Heritage Referral: DA 2021/0250

Casino Memorial Pool

Prepared by
CLARENCE HERITAGE
for Richmond Valley Council

EXISTING METAL GATES- TO BE REMOVED

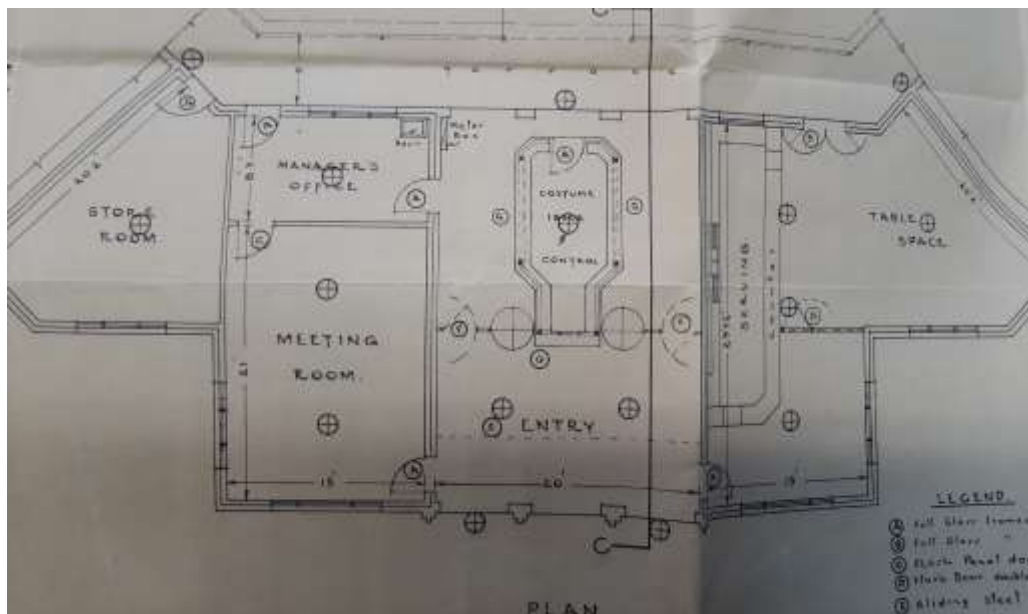
No information was provided in the SEE regarding the significance of these gates. The early photograph of the facade on RVC files shows that the three openings were not originally gated on the frontage, and there was a sliding metal screen setback behind the entry which is different in design to the curved gates.

It can be concluded that the curved metal gates are not an original element, and their removal would not have an adverse impact upon the aesthetic or historic significance of the façade.
